Access Compliance Report

Public Rights-of-Way

Intersection ID: 29992	Main Street: REIGATE_RD	Cross Street: KEMPSFORD_DR	Location:	N
ADA ID: 8456F8A9E6D9	Ramp Type: PerpDiag	Initial Pass/Fail: Fail	Overall Compliance: No	Severity Score: 22.5
Codes/Mitigation Info/Possible Solution		Field Measurements/Component Compliance

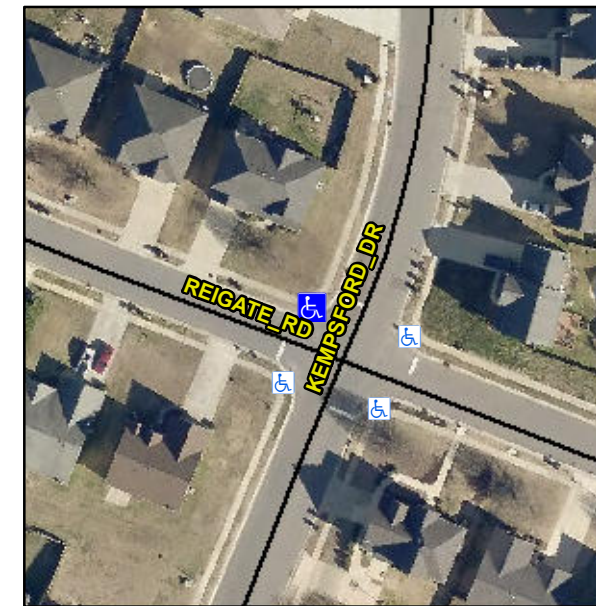
Not Found, R304.5.1, R304.2.2, R304.5.3

Compliance	Description	Data	Compliance	Description	Data
N/A	Ramp Length (in)	47.5	No	Ramp Slope (%)	8.4
No	Ramp Width (in)	41.0	No	Ramp XSlope (%)	4.8
N/A	Flare Type LT	N/A	N/A	Flare Type RT	N/A
N/A	Flare Slope LT (%)	N/A	N/A	Flare Slope RT (%)	N/A
N/A	Flare Traversable LT?	N/A	N/A	Flare Traversable RT?	N/A
N/A	Landing Length (in)	N/A	N/A	DWS Provided?	N/A
N/A	Landing Width (in)	N/A	N/A	DWS Contrast?	N/A
N/A	Landing Slope (%)	N/A	N/A	DWS Length (in)	N/A
N/A	Landing X Slope (%)	N/A	N/A	DWS Full Width?	N/A
N/A	Landing Curb? (Y/N)	N/A	N/A	DWS Offset (in)	N/A
N/A	Shared Landing?	N/A			
N/A	Gutter Ponding?	N/A	N/A	Gutter Slope (%)	N/A
N/A	Gutter Lip Ht (in)	N/A	N/A	Gutter X Slope (%)	N/A
N/A	Painted X Walk1?	No	N/A	Painted X Walk2?	No
	X Walk 1 Direction	To SE		X Walk 2 Direction	To SW
N/A	X Walk 1 Width (in)	N/A	N/A	X Walk 2 Width (in)	N/A
	X Walk 1 Slope (%)	3.3		X Walk 2 Slope (%)	3.9
	X Walk 1 X Slope (%)	3.9		X Walk 2 X Slope (%)	1.1

Remove & Replace Curb Ramp With Two New Directional Ramps or Equivalent.
